ENVIRONMENTAL IMPACT APPRAISAL

EXXON NUCLEAR COMPANY
NUCLEAR FUEL FABRICATION PLANT
RICHLAND, WASHINGTON

RELATED TO LICENSE RENEWAL OF SPECIAL
NUCLEAR MATERIALS LICENSE NO. SNM-1227
DOCKET NO. 70-1257

U. S. NUCLEAR REGULATORY COMMISSION

Figure 3.13

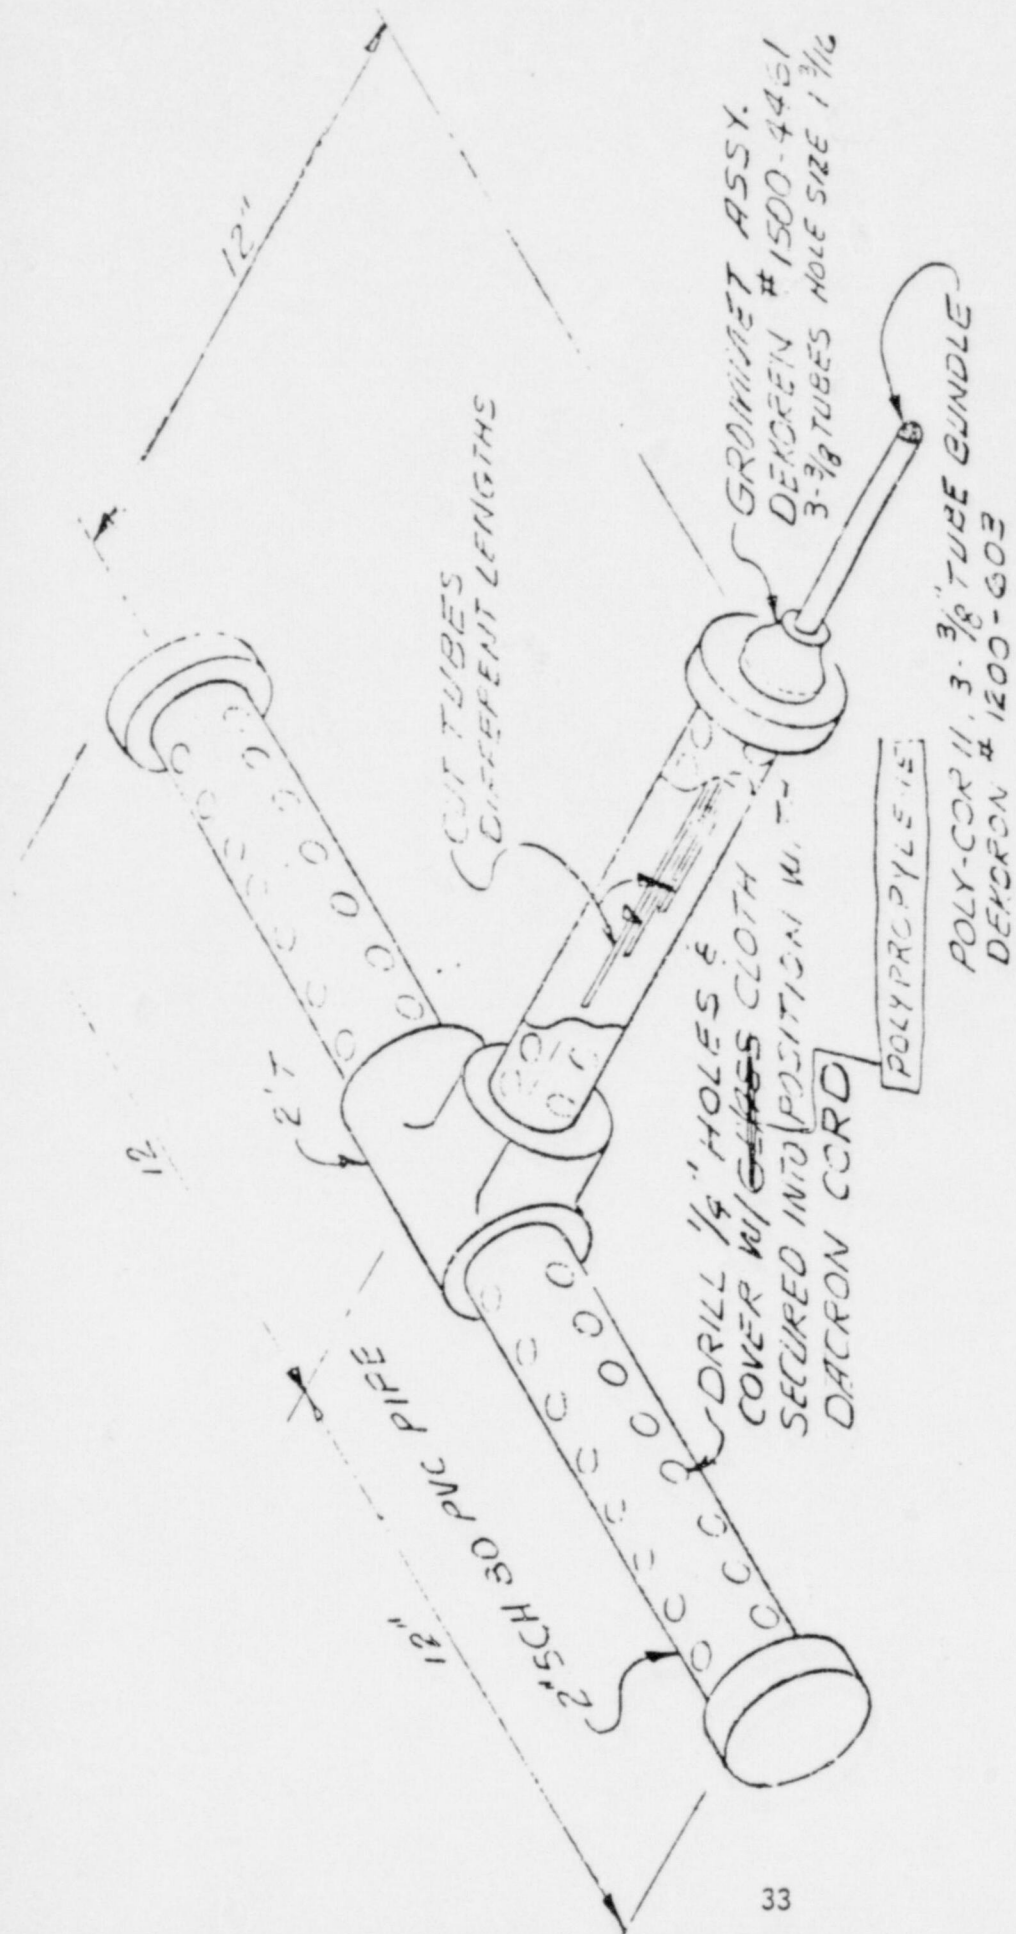
The double-Hypalon liner system consists of two layers of Hypalon material with a 4 to 6 inch thick intermediate layer of sand. Leak monitoring devices, like the one shown in Figure 3.13, are installed in the sand layer. There are presently 21, 10, 35 and 26 leak monitoring devices installed in lagoons number 1, 2, 3, and 4 respectively. In addition to the between liner leak detection system ENC has installed a total of 8 leak monitoring devices that are under both liners. ENC staff states that this leak monitoring system works, as they have detected a leak in the upper Hypalon liner in lagoon number 2 during 1980.

- 1) The between and below liners leak detection system be incorporated as part of the groundwater monitoring systems.
- 2) Action levels for the between and below liners leak detection system be prepared.
- 3) The licensee be required to notify NRC promptly whenever the investigate action level for the between or below liner leak detection system is exceeded. Furthermore, whenever the investigate action level is exceeded the licensee should prepare an initial assessment and describe the actions planned to correct the leakage. This assessment should be provided to NRC within 3 months and thereafter, while remaining in the investigative range, should be documented and provided to NRC on a semiannual basis.
- 4) The licensee should establish a system of test wells to monitor the contaminated groundwater plume.

Figure 3.15 Fluoride Released from UO_2 Exhaust Stacks Per Ton of Uranium Throughput

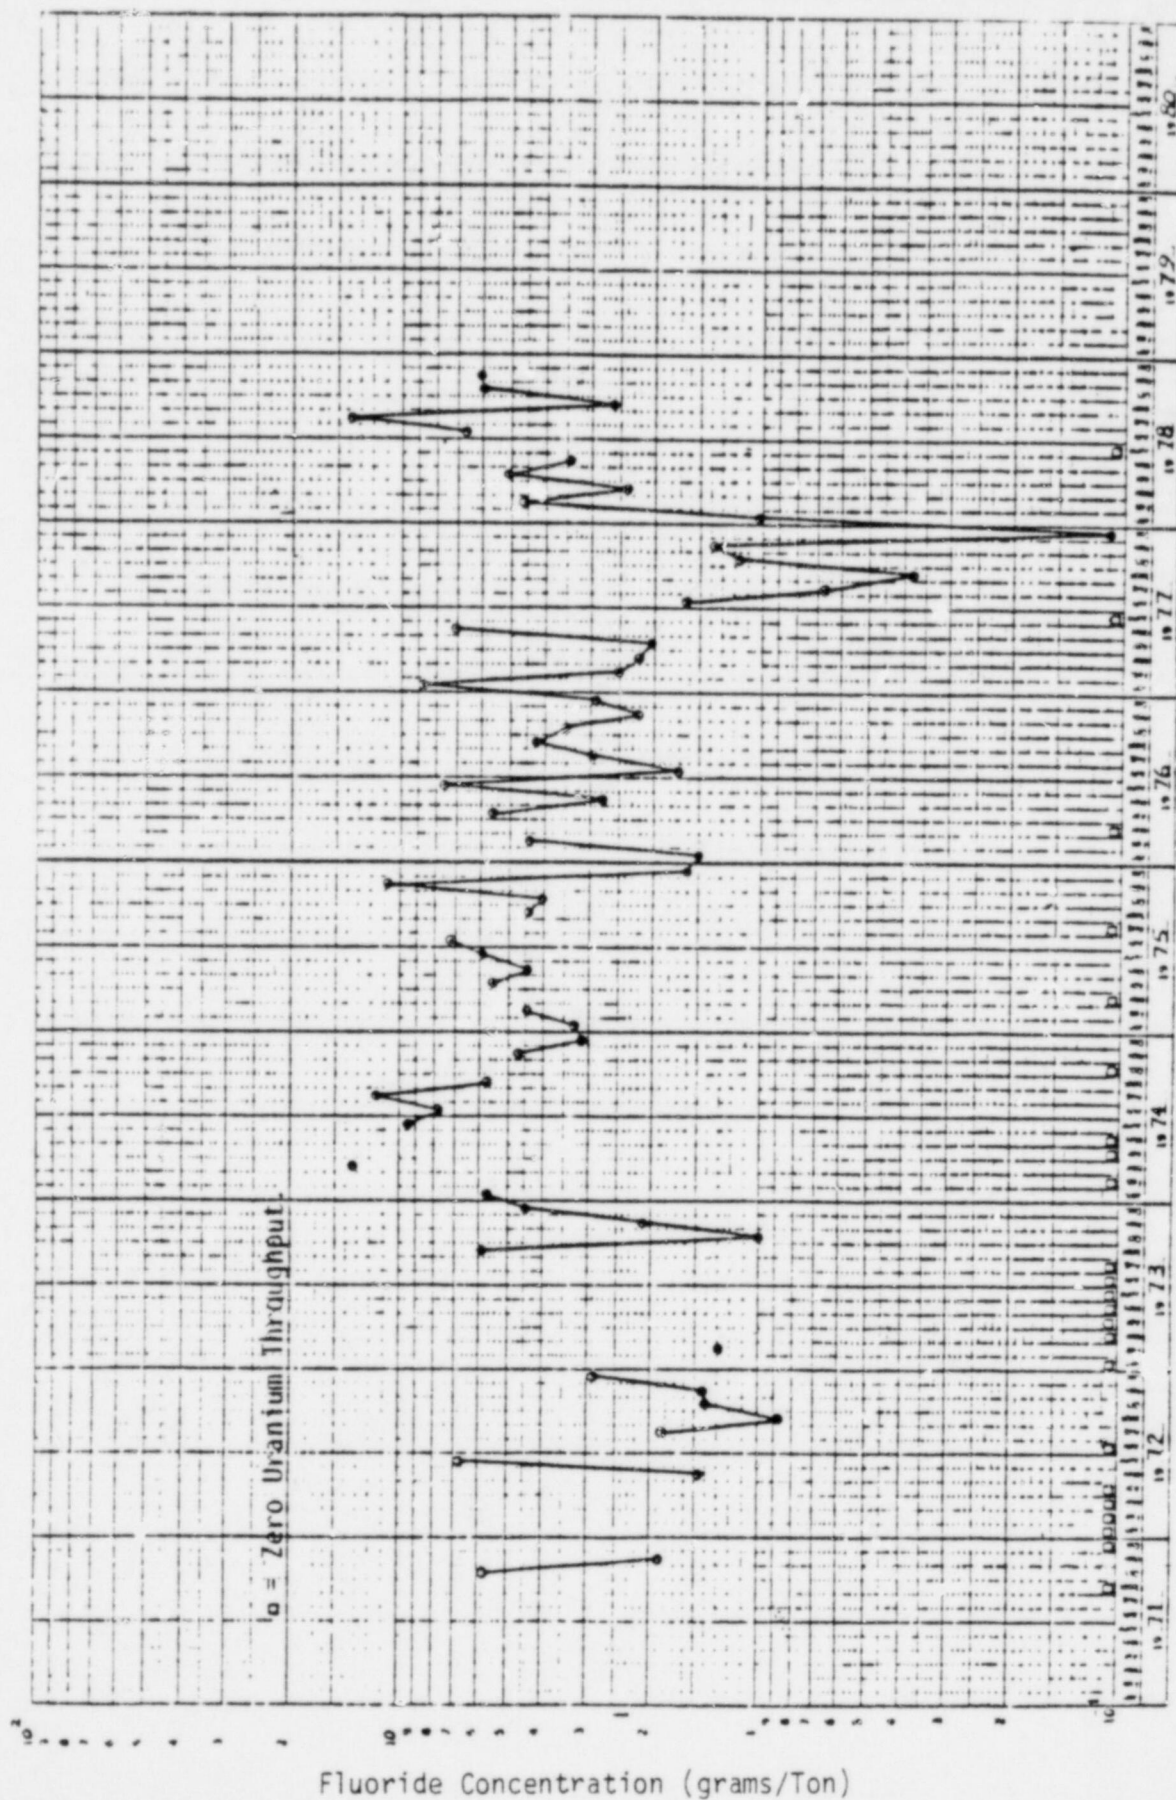
The stack exhaust from the UF_6 - UO_2 conversion process is continuously sampled for fluoride and analyzed at weekly intervals. Figure 3.15 shows the measured quantity of fluoride released per 1,000 kilograms of uranium processed. Additionally, the plant environmental surveillance program includes the collection of filter paper samples for fluoride analysis at selected locations

Thus, the staff concludes that the concentration of fluorides in vegetation measured as part of the ENC environment surveillance program is inconsistent with the ENC data on fluoride releases per ton uranium processed. The staff estimates that the fluoride releases are from a few hundred to a few thousand grams per ton uranium.
